STAFF RECOMMENDATION 1000 South Douglas Avenue April 20, 2016

Application: New construction—Infill
District: Waverly-Belmont Neighborhood Conservation Zoning Overlay
Council District: 07
Map and Parcel Number: 10513015400
Applicant: Tucker Tingle, Allard Ward Architects
Project Lead: Melissa Baldock, melissa.baldock@nashville.gov

Description of Project: Application is to construct infill on a vacant lot.

Site Plan

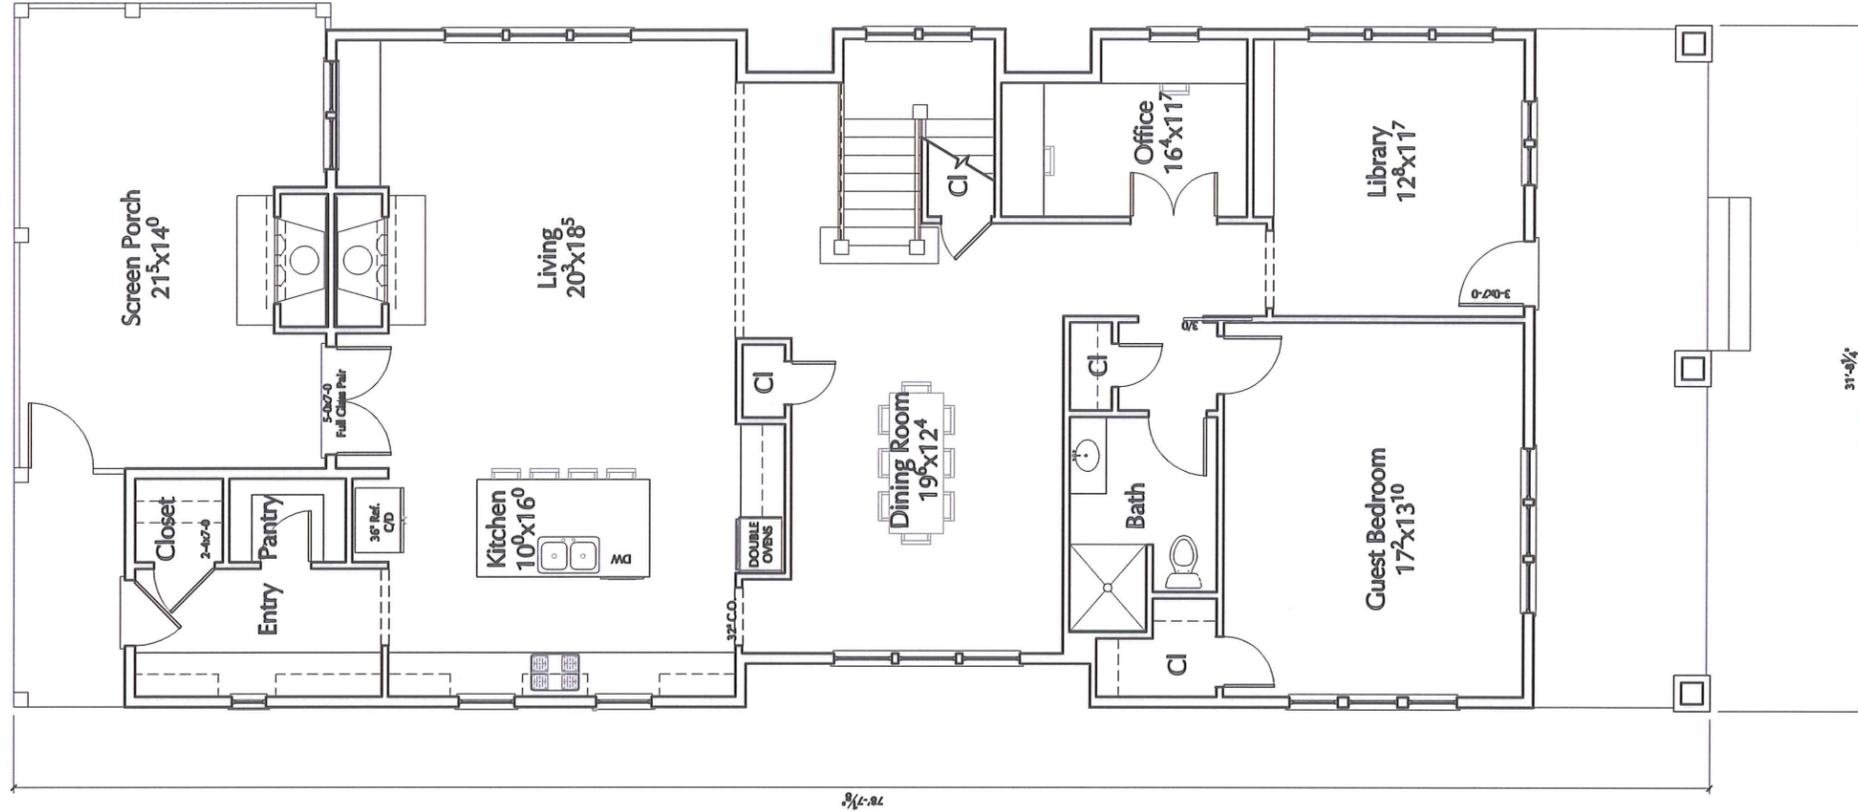
Setback & Rhythm of Spacing: The propose infill will meet all base zoning requirements for setbacks. It will be five feet (5') from the left/west property line and more than thirteen feet (13') from the right/10th Avenue South property line. The infill will be shifted on the lot, away from 10th Avenue South. Staff finds this to be appropriate because the previous historic house on the lot was also shifted in a similar manner, and the shifting pushes the massing of the house away from the side street.

Orientation: The infill is oriented towards South Douglas Avenue, which is appropriate. There a full width, recessed, front porch that is nine feet (9') deep. A walkway will run from the sidewalk on South Douglas to the front porch. Vehicular access to the site will be via the alley, where there will be a twenty-two foot by twenty-two foot (22' X 22') gravel parking area. Staff finds that the infill's orientation meets Section III.F. of the design guidelines.

Appurtenances & Utilities: The location of the HVAC and other utilities was not noted. Staff asks that the HVAC be located on the rear façade, or on either side beyond the midpoint of the house. A new twenty-two foot by twenty-two foot (22' X 22') gravel parking area will be added to the rear of the property, accessed via the alley and pushed away from 10th Avenue South towards the west end of the lot. Staff finds that the known appurtenances and utilities meet Section III.I. of the design guidelines.

South Douglas Avenue Elevation

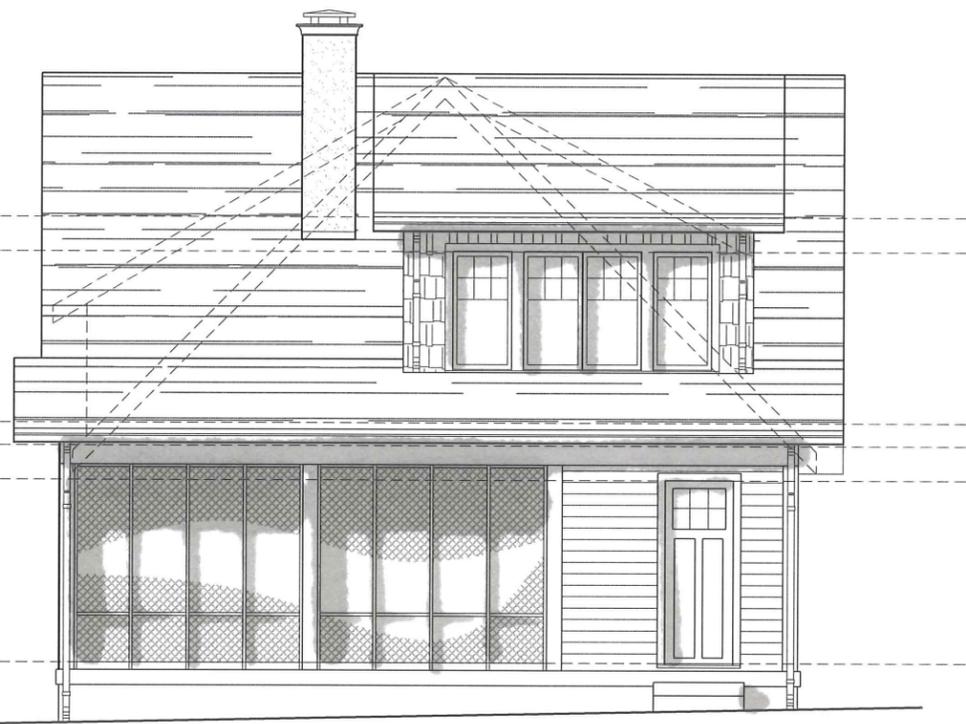
Height & Scale: The proposed infill will be one-and-a-half stories tall, with an eave height of ten feet, six inches (10'6") and a ridge height of twenty-seven feet, six inches (27'6"), from grade. Staff finds that this meets the historic context, where most historic houses are one or one-and-one-half stories tall with heights ranging from eighteen to thirty feet (18'-30'). The foundation height is drawn as two feet (2'), which is appropriate, but staff recommends inspection of the foundation height and the finished floor system to ensure their compatibility with the surrounding historic houses.

Materials: The primary cladding material will be smooth-face cement fiberboard with a five inch (5") reveal. Stained cedar shakes will be used as an accent material in the bay, gable fields, and dormers. The trim will be cement fiberboard. The roof will be architectural asphalt shingles, and staff recommends approval of the shingle color. The chimney and the front porch column bases will be stucco. The foundation material was not specified, and staff recommends approval of the foundation material. The windows and doors specifications were likewise not indicated on the drawings, and staff recommends approval of all windows and doors prior to purchase and installation. The porch floor and steps will be concrete. The rear porch will be screened. Staff finds that the known materials meet Section III.D. of the design guidelines.

Roof form: The primary roof form will be a side gable with a 12/12 pitch. The front porch will be recessed and located under the primary roof form. There is a shed dormer with a slope of 6/12 on the front façade. It will be recessed two feet (2') from the front of

the roof. The right/10th Avenue façade contains a second story bay with a shed roof. Staff finds that the proposed roof forms are compatible with the historic context and meet Section III.E. of the design guidelines.

Proportion and Rhythm of Openings: The house's primary windows are generally twice as tall as they are wide, thereby meeting the historic proportion of window openings. There are no large expanses of wall space without a window or door opening. Staff finds that the infill's proportion and rhythm of openings meet Section III.G. of the design guidelines.

1. The finished floor height be consistent with the finished floor heights of the adjacent historic houses, to be verified by MHZC staff in the field;
2. Staff approve the final details, dimensions and materials of windows and doors prior to purchase and installation;
3. Staff approve the foundation material;
4. Staff approve the asphalt shingle color and texture; and
5. The HVAC be located behind the house or on either side facade, beyond the mid-point of the house.
